Reliability Update – MAAC Region

DPL Transmission Zone: b3143 Scope and Cost Change

b3143: Scope and Cost Change

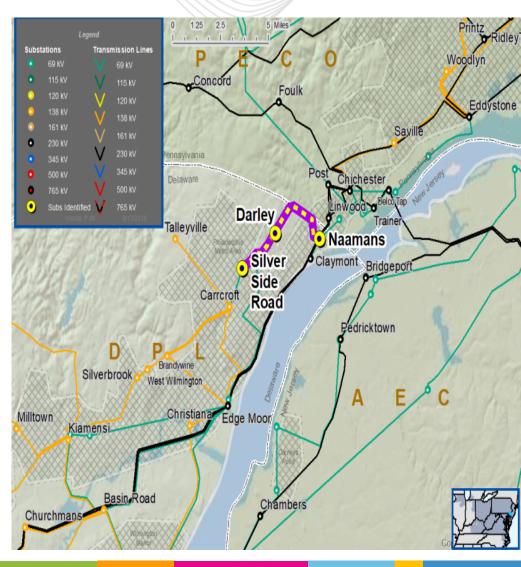
Original: Naamans – Darley – Silver Side Rd 69kV reconductoring Revised: Naamans – Darley – Silver Side Rd 69kV rebuilding Previously Presented: Second Review – SRRTEP-MAAC – 11/19/2019 Criteria Test: Summer and Winter generator deliverability from 2019 RTEP. [GD-S537, GDS538], [GD-W441 and GD-W442]

The Naamans – Darley – Silver Side Rd 69 kV circuit is overloaded for a tower line outage, loss of Edge Moor – Claymont and Edge Moor – Linwood 230 kV circuits, in the Winter generation deliverability study. The circuit is rated at 105N/136E, 137N/175E Summer and 121N/153E, 158N/197E Winter.

Replace terminal equipment and implement reconductoring of the Silverside-Darley and Darley-Naamans 69 kV lines to achieve ratings of 232N/239E summer MVA, 241N/269E winter MVA (Silverside-Darley) and 174N/194E summer MVA, 205N/235E winter MVA (Darley-Naamans). (B3143)

Based on field evaluations of these facilities, in order to achieve higher ratings based on DPL's design standard, a scope change to rebuild, rather than reconductor, is required.

Replace terminal equipment and implement rebuilding of the Silverside-Darley and Darley-Naamans 69 kV lines to achieve ratings of 196N/242E summer MVA, 225N/272E winter MVA on both circuits. (B3143)

Revised Estimated Project Cost : \$21M

Revised Projected In-Service Date: 10/31/2026 (Silverside – Darley, b3143.1), 12/31/2026 (Darley – Naamans, b3143.2) Project Status: EP
